# Access Compliance Report

## Public Rights-of-Way

### (Curb Ramps)

Intersection ID: 53235	Main Street: EVERGREEN_DR	Cross Street: N/A	Location:	N
ADA ID: 096CC8FC1A73	Ramp Type: Perp	Initial Pass/Fail: Fail	Overall Compliance: No	Severity Score: 10

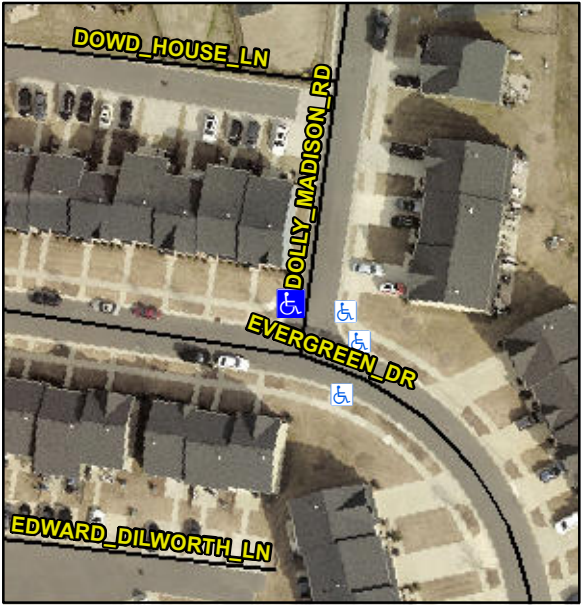
Codes/Mitigation Info/Possible Solution			Field Measurements/Component Compliance		
	Possible Solutions:		<b>Compliance</b>	<b>Description</b>	<b>Data</b>
	Remove & Replace Entire Ramp.		N/A	Ramp Length (in)	72.0
			No	Ramp Width (in)	46.5
			N/A	Flare Type LT	N/A
			N/A	Flare Slope LT (%)	N/A
			N/A	Flare Traversable LT?	N/A
			N/A	Landing Length (in)	N/A
			N/A	Landing Width (in)	N/A
			N/A	Landing Slope (%)	N/A
			N/A	Landing X Slope (%)	N/A
<p>Surveyor Notes:</p> <p>N/A</p> <p>PROW/ADA:</p> <p>Not Found, R304.5.1, R304.5.3</p>			N/A	Flare Type RT	N/A
			N/A	Flare Slope RT (%)	N/A
			N/A	Flare Traversable RT?	N/A
			N/A	DWS Provided?	N/A
			N/A	DWS Contrast?	N/A
			N/A	DWS Length (in)	N/A
			N/A	DWS Full Width?	N/A
			N/A	DWS Offset (in)	N/A
			N/A	Shared Landing?	N/A
			N/A	Gutter Ponding?	N/A
			N/A	Gutter Lip Ht (in)	N/A
			N/A	Painted X Walk1?	No
				X Walk 1 Direction	To SE
			N/A	X Walk 1 Width (in)	N/A

X Walk 1 Slope (%)	3.8
				X Walk 1 X Slope (%)	0.1
			N/A	Ramp inside XWalk1?	N/A
			N/A	Ramp inside XWalk2?	N/A
			N/A	Road Slope (%)	N/A
			N/A	Road X Slope (%)	N/A
			N/A	Any Obstructions?	N/A
				Obstruction Type	
			N/A		
			N/A		
			N/A		
			N/A		
			N/A		
			N/A		
			N/A		
			N/A		
<p>Total Cost:</p> <p>\$ 1850.00</p>			Yes	Surface Condition? (G/P)	Good
